This memorandum has been prepared in response to the request for staff memorandum dated January 24, 2012 in the matter of applications for transfer/new water rights No. 73811, 73834, 63-32499, 61-12095, 61-12096, 63-32703, 61-12256, and 63-33344. The following information was requested:

RE: *Response to IDWR Staff Memo regarding the sufficiency of water supply for water right applications and transfers along the I-84 corridor*

Rebuttal Report of Christian R. Petrich

In the Matter of Application for Transfer No. 73811 (Shekinah Industries); Application for Transfer No. 73834 (Orchard Ranch); Application for Permit No. 63-32499 (Mayfield Townsite); Application for Permit No. 61-12095 (Nevid-Corder); Application for Permit No. 61-12096 (Nevid); Application for Permit No. 63-32703 (Orchard Ranch); Application for Permit No. 61-12256 (Intermountain Sewer & Water); Application for Permit No. 63-33344 (ARK Properties-Mayfield Townsite) before the Idaho Department of Water Resources

Figure 4. Water table contour map for October, 2011.

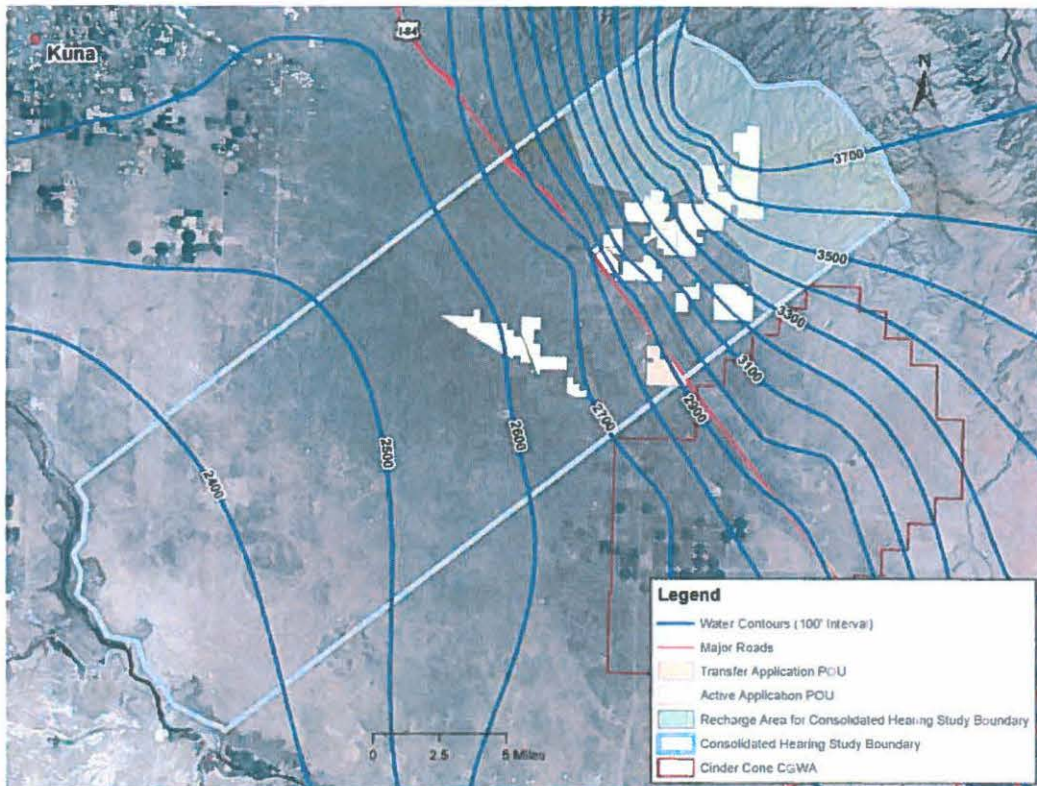
That said, the southwest-northeast study-area boundaries are not entirely perpendicular to IDWR's groundwater-level contours (see Figure 4 of the IDWR Staff Memo) in the southern portion of the study area. As such, the study boundaries appear to not be aligned along regional flow lines in this area. However, Lindholm et al. (1988) defined regional groundwater-level contours using a much larger (and more regional) data set. Figure 1 shows (a) Lindholm et al.'s groundwater-level contours, (b) IDWR groundwater-level contours presented in Figure 4 of the IDWR Staff Memo, and (c) IDWR water-level contours that SPF reinterpreted based on the previous Lindholm et al. contours. Inferred groundwater flow lines based on the IDWR contours and Lindholm et al. regional groundwater-level contours represent a reasonable basis for IDWR's southwest-northeast study-area boundaries.

Figure 5. Groundwater level change maps for the Cinder Cone CGWA for the fall season between the years (a) 1981 and 1991, (b) 1991 and 2001, (c) 2001 and 2011, and (d) 1981 and 2011.

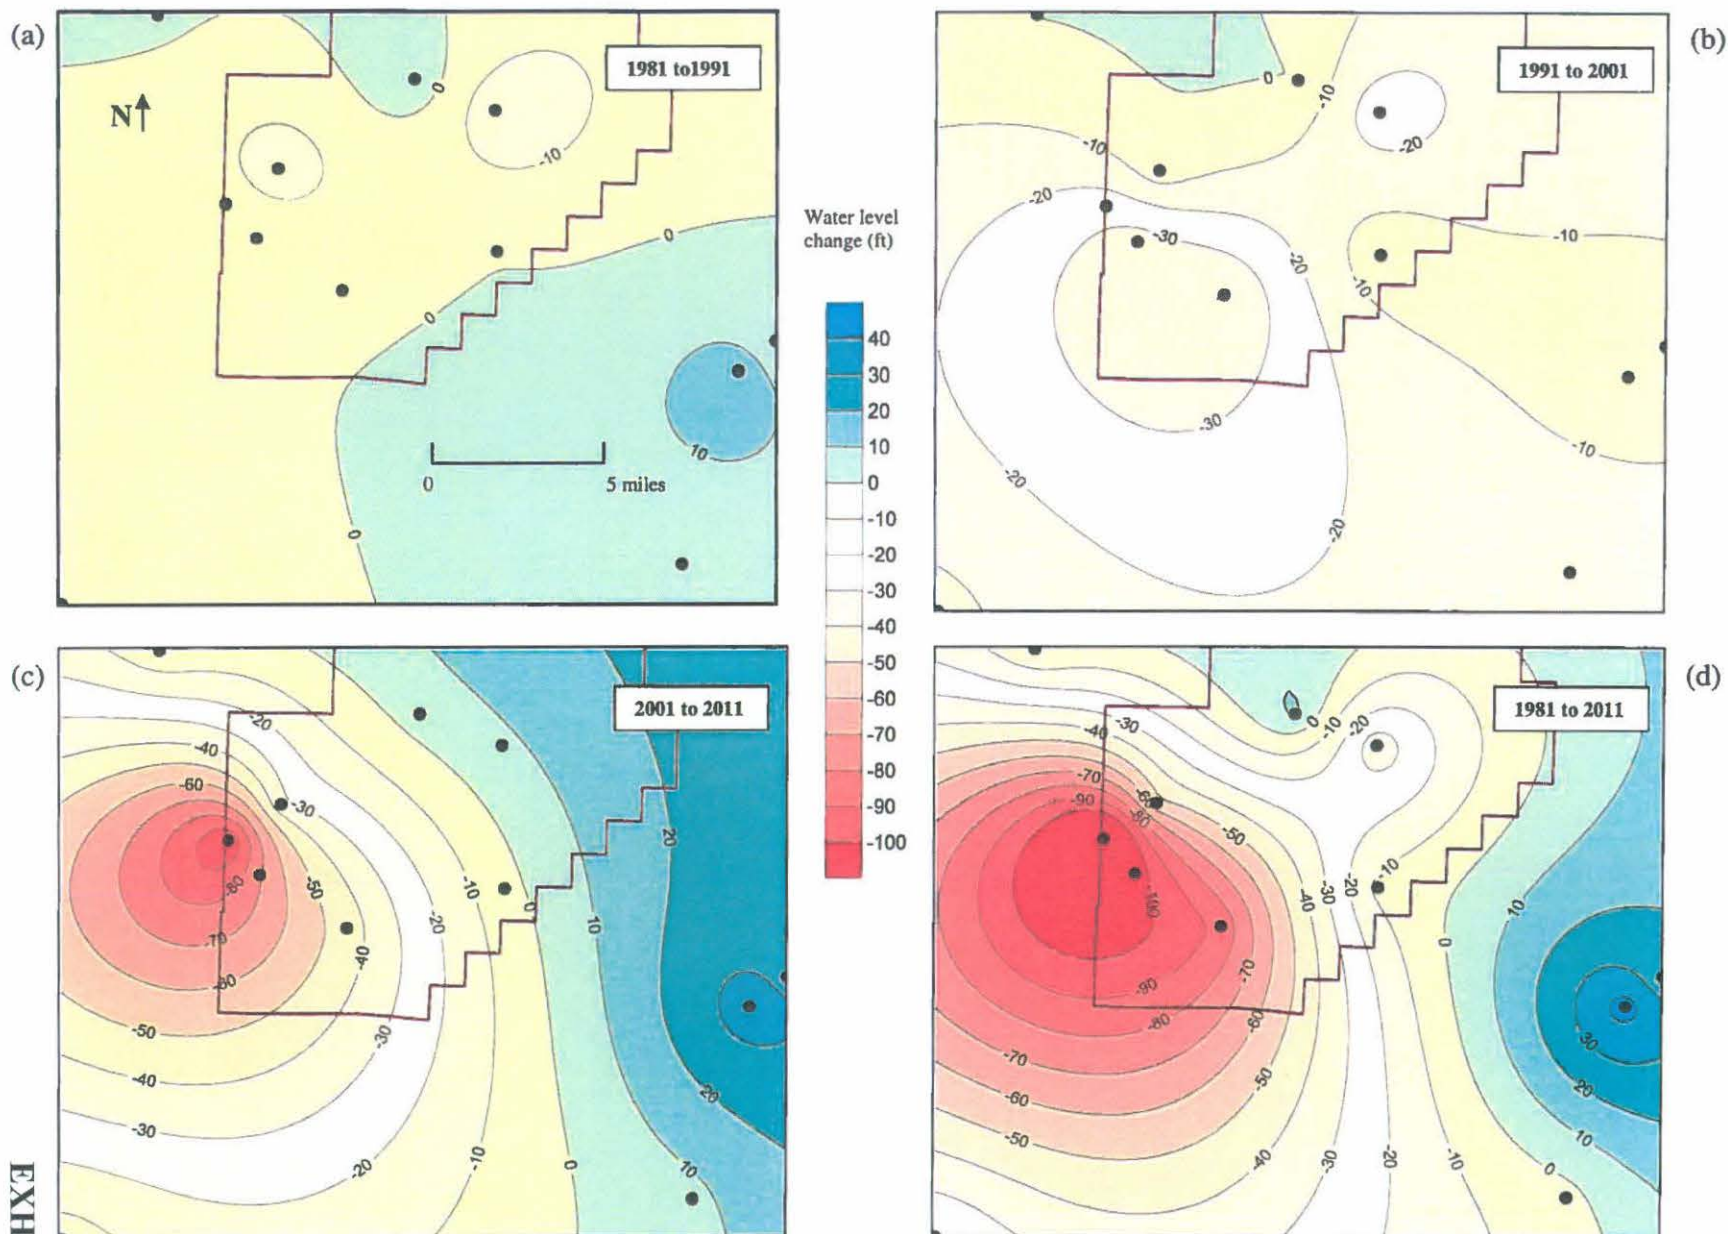
4. There clearly have been groundwater-level declines within the Cinder Cone Butte CGWA, but the degree to which water level declines within the CGWA have extended outside of the CGWA is unclear. Groundwater-level contours shown Figure 5 of the IDWR Staff Memo⁸ show substantial declines extending west and southwest (i.e., outside) of the CGWA in the consolidated cases study area, but these depictions of the study-area groundwater-level declines represent a software interpolation unsupported by actual groundwater-level data.

3. ERO uses Figure 5 of the IDWR Staff Memo to suggest that a 20-mile diameter area of groundwater-level decline stemming from pumping in the Cinder Cone Butte Critical Ground Water Area (CGWA) extends substantially into the consolidated cases study area. However, the IDWR depictions of groundwater-level declines outside of the CGWA are based on software interpolation unsupported by actual groundwater-level data.

ERO's argument appears to be based on a map of purported groundwater-level declines stemming from Cinder Cone Butte CGWA pumping (see Figure 5, IDWR Staff Memo). However, the IDWR depictions of groundwater-level declines outside of the CGWA are based on software interpolation unsupported by actual groundwater-level data. Furthermore, Figure 4 of the IDWR Staff Memo also does not appear to indicate groundwater-level declines within the study area stemming from Cinder Cone Butte CGWA pumping. Thus, neither Figures 4 nor 5 of the IDWR Staff Memo support the concept of a 20-mile diameter water-level decline attributable to pumping in the Cinder Cone Butte CGWA.

Perhaps more telling is that approximately 40 years of pumping in the Cinder Cone Butte area has not resulted in the type of water-level decline projected by ERO's Theis results. IDWR Figure 5(d) suggests that there has been zero water-level decline since 1981 in the vicinity of the proposed applications and transfers as a result of Cinder Cone Butte area pumping over the past several decades. Thus, although ERO's Theis analysis might predict widespread water-level decline within the study area as a result of proposed pumping, monitoring data from actual pumping in the Cinder Cone Butte area demonstrate otherwise.

Figure 1. Inferred groundwater flow directions at study-area boundaries.

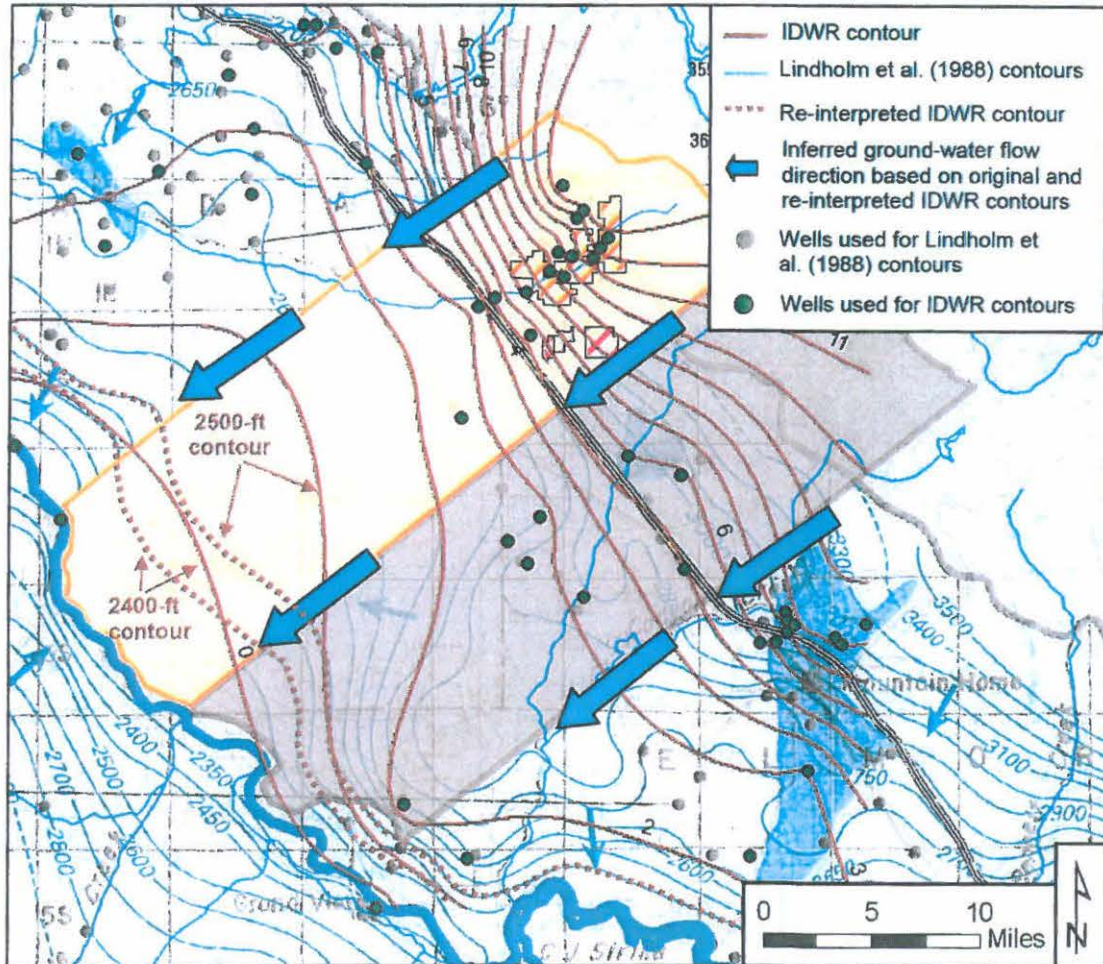
Response. The study area designated by IDWR for evaluating groundwater supply is appropriately sized and technically defensible. The study area encompasses all of the proposed points of diversion and proposed places of use. The study area is defined by defensible boundaries.

study area². As such, the study area defined by IDWR for purposes of computing a water budget and evaluating water supply is reasonable.

Figure 3. Locations of wells in the upper Blacks Creek drainage with groundwater-level data.

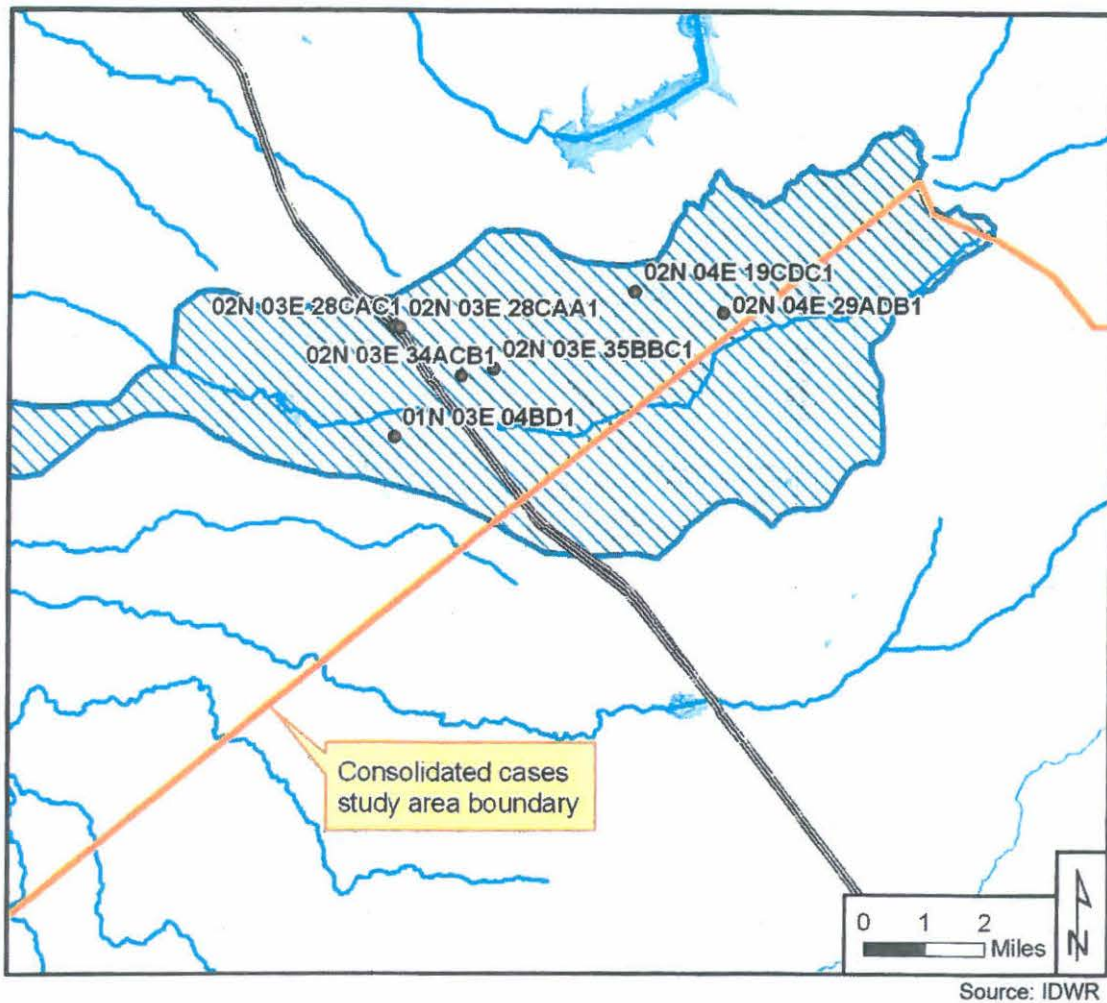
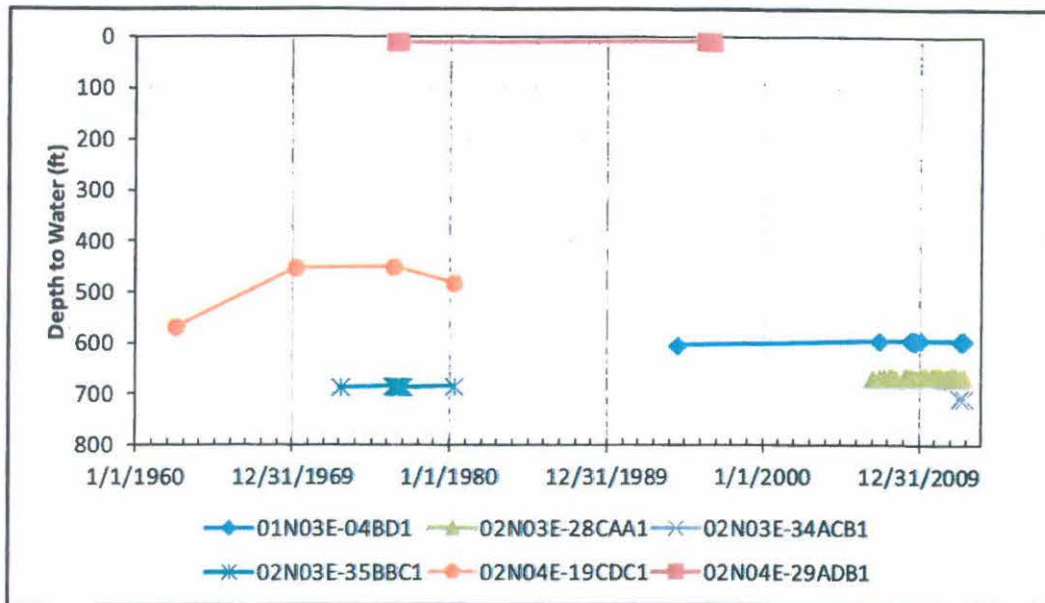
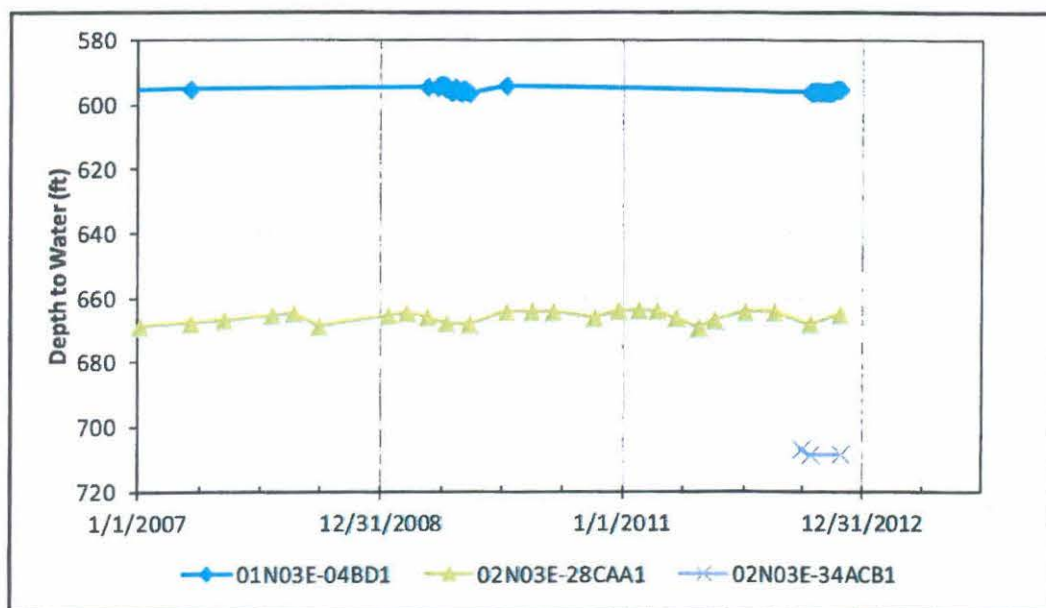
Locations of wells in the upper Blacks Creek drainage with publicly-available groundwater-level data are shown in Figure 3. Hydrographs from these wells (Figure 4 and Figure 5), including a well within ¼-mile from the point of diversion for water right 63-11540, show no groundwater-level declines, indicating that diversions authorized under water right 63-11540 have not created (and therefore likely will not create) groundwater-level declines in the upper Blacks Creek drainage area. Thus, it appears that ERO's concerns about long-term effects of pumping outside this portion of the study area are unfounded.

Figure 8. Portion of "non-recharge area" from which recharge capture is likely.

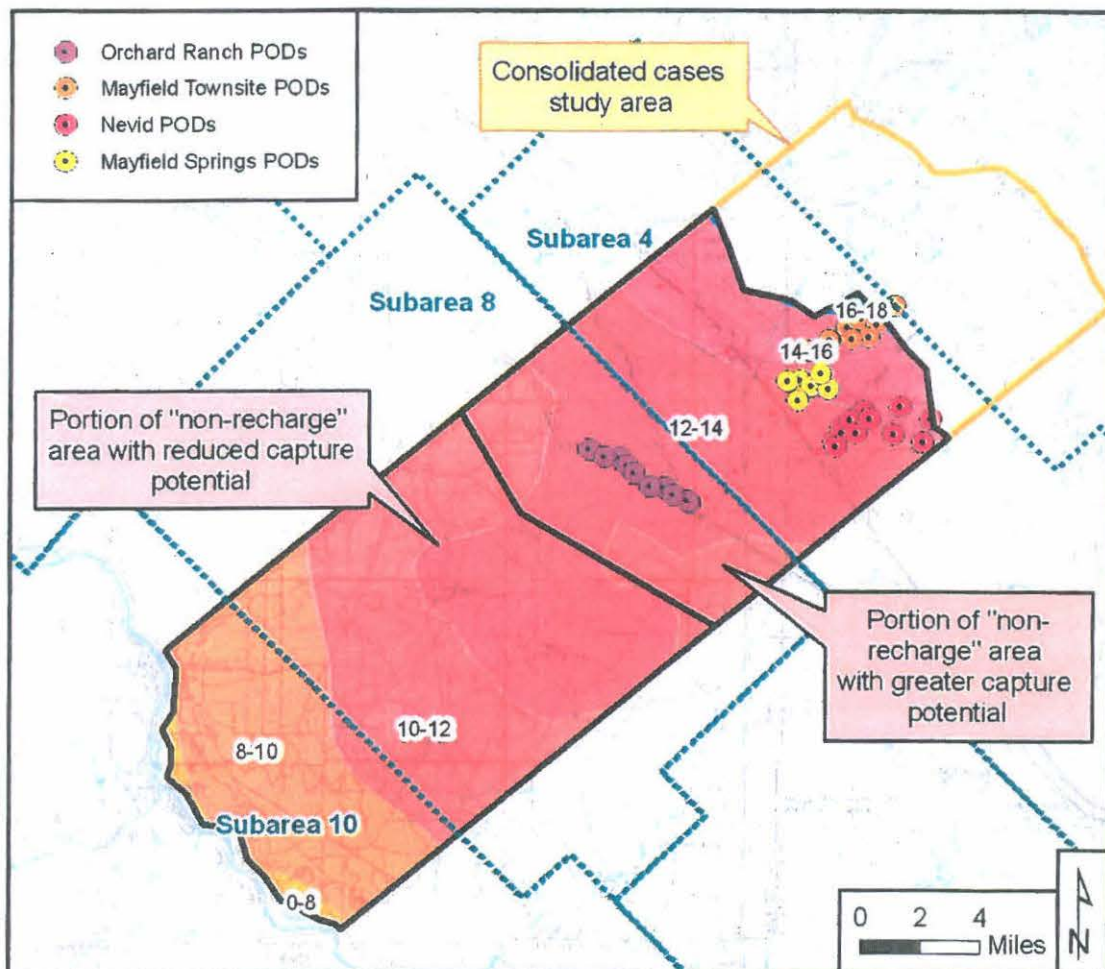
Figure 8 illustrates a portion of the "non-recharge" area with greater potential of capturing recharge originating from the "non-recharge" area and an area with reduced capture potential. The line separating these two portions of the "non-recharge" area is approximately 3 miles down-gradient of the Orchard Ranch wells, which presumably could develop an approximate 3-mile capture radius.

The amount of average annual recharge generated within the portion of the "non-recharge" area having greater capture potential was estimated using the same estimated USGS recharge percentages (Newton, 1991) and PRISM data that IDWR used in developing a recharge estimate for the "non-recharge" area. Using this approach, the amount of recharge within the portion of the "non-recharge" area having greater capture potential is approximately 1,950 acre-feet per year (Table 1).

Figure 9. Comparison of Newton (1991) model zone locations interpreted by IDWR and SPF.

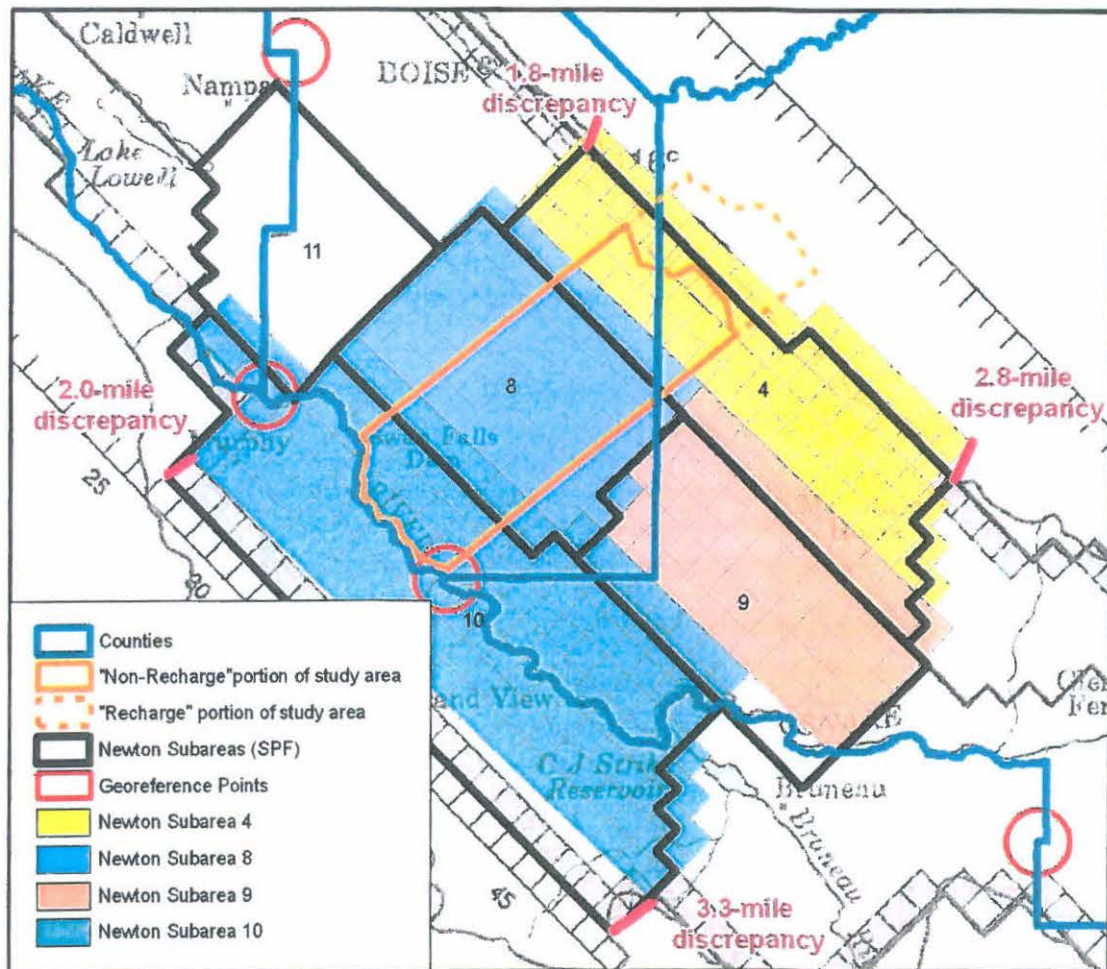
In calculating recharge for the "non-recharge" area using USGS subareas we found a discrepancy in IDWR's geo-referencing of the Newton (1991) subarea map. Correcting this discrepancy resulted in a recharge estimate of 3,000 AF for the "non-recharge" area, which is approximately 340 AF greater than the 2,660 AF recharge volume estimate presented in the IDWR Staff Memo (Table 2).

The geo-referencing discrepancy is illustrated in Figure 9. SPF scanned Figure 17 in the Newton (1991) report and geo-referenced this map using county shapefile polylines (6 points) as reference points. IDWR's geo-referencing was off by distances

of 1.8 to 3.3 miles at four representative corner points (Figure 9). Examples of SPF's geo-referencing points are shown in Figure 10. The net result is that there is a larger portion of USGS subarea 4 and a smaller portion of Subarea 10 in the consolidated cases study area than calculated by IDWR.
